**Report: TAB Report**  
**Function: Test, Adjust, & Balance**  
**Date: 11/07/2025**  
**Completed By: National TAB**

**PROJECT**  
**11-03-25 QT #1435 GLENDALE, AZ**

# National TAB

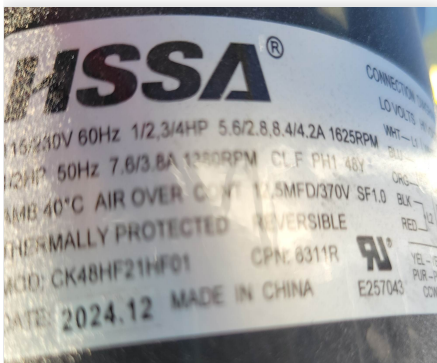
**Issue Name :** EF-1: EXHAUST MOTOR TOO HIGH, SPEED CONTROLLER BAD  
**Description :** Exhaust fan should be 0.5HP and within 5.6A. Appears to be 0.75HP since fan current = 5.9A to 6.0A. Speed controller is not functioning correctly, barely adjusts fan speed, and doesn't turn unit off when clicked into 'off' position. Speed controller is set to lowest position and flow is twice design (1562/750cfm). Recommend service.  
**Created By :** National TAB                      **Assigned To :** National TAB - Dan Hertenstein  
**Status :** Open  
**Priority :** High                                      **Asset Tag :** EF1  
**Originated Date :** 11/06/2025 - Christine Weale - National TAB

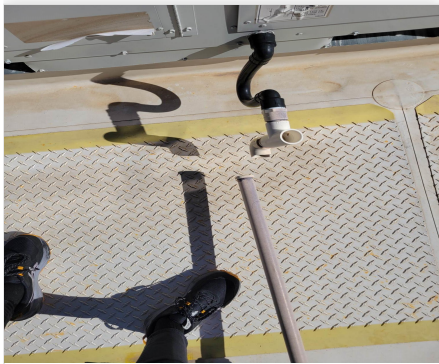
**Issue Name :** RTU-1: CONDENSATE PIPE BROKEN  
**Description :** Condensate pipe is broken and will pool in front of unit.  
**Created By :** National TAB                      **Assigned To :** National TAB - Dan Hertenstein  
**Status :** Open  
**Priority :** InfoOnly                                      **Asset Tag :** RT-1  
**Originated Date :** 11/06/2025 - Christine Weale - National TAB

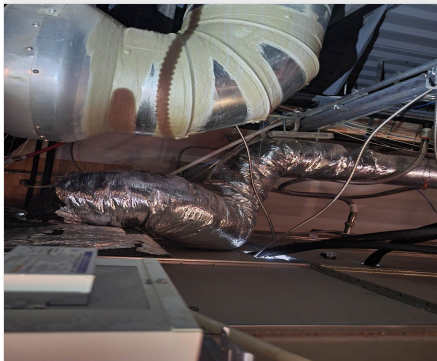
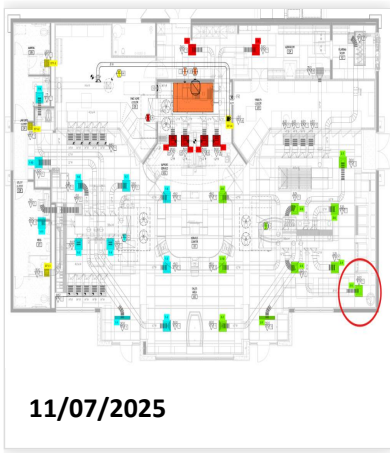
**Issue Name :** RTU-2: BACK AREA NOT CONDITIONED  
**Description :** Diffuser 2-5 and duct are laying on top of the ceiling, pictures show where diffuser should be installed and another place it could be rerouted. Damper is closed, but back area is not being conditioned and may cause issues.  
**Created By :** National TAB                      **Assigned To :** National TAB - Dan Hertenstein  
**Status :** Open  
**Priority :** Medium                                      **Asset Tag :** SGRD5  
**Originated Date :** 11/06/2025 - Christine Weale - National TAB

- **11/07/2025 National TAB - Michael McDonnell**
  - Location of Diffuser 2-5 and unconditioned space.

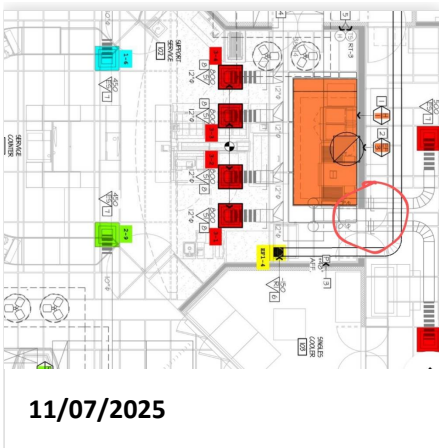
**Issue Name :** RTU-3: DAMPERS INACCESSIBLE  
**Description :** Dampers for Diffusers 3-5 and 3-6, which serve the BOH, are inaccessible. 3-5 is above design and 3-6 is below design as a result. Total airflow for BOH area is within design. Recommend moving to a more accessible location in future stores so diffusers can be properly balanced.  
**Created By :** National TAB                      **Assigned To :** National TAB - Dan Hertenstein  
**Status :** Open  
**Priority :** Low                                      **Asset Tag :** SGRD6  
**Originated Date :** 11/06/2025 - Christine Weale - National TAB
